ALAMEDA POINT DRAFT EIR – H.O.M.E.S. COMMENTARY

TO: Andrew Thomas
City Planner
2263 Santa Clara Avenue
Alameda, CA 94501

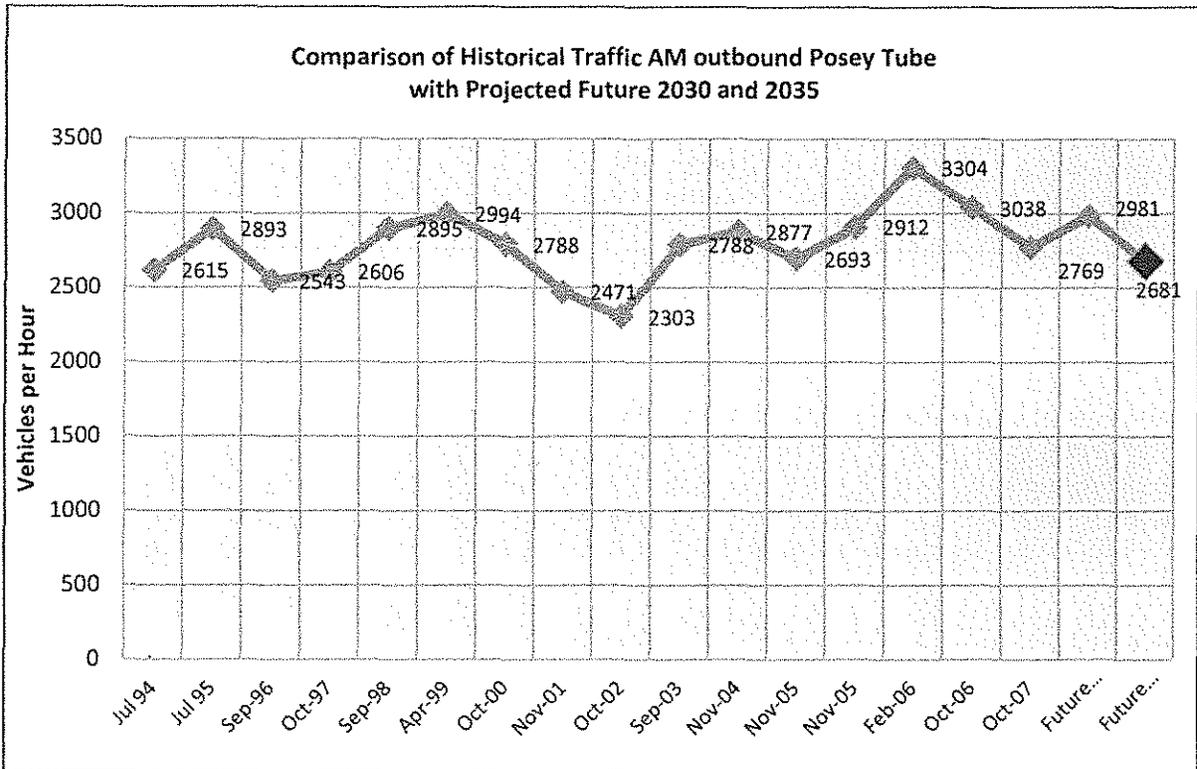
Our analysis indicates there are inconsistencies in the traffic model that was used to project future vehicle trips in the AM and PM Peak Period. The finding that only 1 vehicle trip per hour in the AM Peak Period at the 6th & Jackson intersection that is a direct result of the project leaves one to question the validity of the model. Furthermore, the back-up analysis has no indication of the traffic distribution from the Project, nor from where traffic is coming that is headed to the Project.

Additional inconsistencies that were identified include:

- **Minuscule or no** increases in exiting traffic at the other four island gateways in the AM peak hour due to the project. The DEIR traffic analysis does not accurately show traffic volumes exiting the Posey Tube in the AM peak hour in stating that the project would only generate one car outbound through the Posey Tube, as seen in the table below, and minimal traffic increases at the other four island gateways. This does not seem accurate, and the analysis for this should be checked. It is "unimaginable" that the traffic in the AM peak hour would be one car per hour for the "Existing with Project" condition and then only eight cars per hour for "Cumulative with Project" condition from the Alameda Point Project. For the PM peak hour, the project volume into the Posey Tube and into the Webster Tube at only 102 vph and 104 vph, respectively, for the cumulative plus project is also unimaginable.

- 17-4 The Draft EIR identifies that the proposed project will have significant transportation impacts in Oakland. This would not be the case if the project were only generating one (1) single automobile through the Posey Tube. It should be noted that the City of Oakland thresholds of significance require that the analysis examine peak hour conditions, and the Webster and Posey Tubes have a limited capacity to accept additional traffic during the peak hours. As documented in the EIR for the Alameda Point General Plan Amendment in 2003, the Alameda Landing Supplemental EIR in 2006, and a variety of other City of Alameda traffic studies over the last 10 years, the capacity of the Webster and Posey Tubes is fixed to a specific number of automobiles that can cross between the two cities during the AM or PM peak commute periods. The City of Alameda conducts an annual count of automobiles using the tubes in the AM and PM periods and reports those counts annually. It is well documented that the existing tubes have been at or near capacity for the last six to seven years. Therefore, the Draft EIR found that regional growth and other development that is planned in Alameda over the next 20 to 30 years will exceed the capacity of the Webster and Posey Tubes. The Draft EIR finds that the limited capacity of the tube causes many automobile trips to divert to other crossings during the AM and PM peak periods. In addition to diversion of commute hour traffic, it should be expected that the peak hours of congestion will "spread" as more commuters choose to leave earlier or delay their commute to later in the morning to avoid the peak hours of congestion. Also see response to Comment 30-7. Model output plot showing the assignment of project trips on the roadway network are available at the city offices for review. Also please see responses to Comments 2-1 and Comment 7-7 related to the regional transportation model.

17-5 The change in traffic volumes between the ‘no project’ and ‘with project’ during the AM and PM peak hours at the Alameda island gateways reflect both the traffic generated by the project as well as diversion to existing and future non-project traffic due to the capacity constraint in the peak direction. That is, that although the Webster and Posey Tubes are the closest automobile access points to the regional transportation network and I-880 from the project site, because the Tubes are currently operating near capacity and do not have additional capacity to accept significantly more automobile trips during the peak commute periods, the Model assigned many project trips that would use the Tubes, if capacity were available, to other routes. (It is noted that the Tubes would still be the route of choice during non-peak periods, when capacity exists; however, the analysis in the EIR focuses on the peak periods of commute traffic, as is common and appropriate in CEQA analysis.) Thus, the Model projects that many of the additional trips will be diverted to the other Estuary crossings at the Park Street Bridge, the Fruitvale Bridge, the High Street Bridge and the Bay Farm Bridge.

To clarify, for the volume shown in the table, the column labeled “Project Volume” represents this change in volume due to the proposed project, not just project related traffic. As noted in the comment, this constraint is particularly evident in the outbound Posey Tube in the AM, where the change in volume with the project is 1 car under existing conditions and 8 cars under cumulative conditions. Under the Existing Plus Project Conditions scenario, the total change in outbound traffic is represented at other Estuary crossings, which represents traffic diverted from the Tubes. Under cumulative conditions, other growth in Alameda would result in a better jobs-housing balance thereby reducing the total outbound at island gateways during the AM peak hour. For more details on the travel demand model used for the analysis, see responses to Comments 2-1 and 7-7.
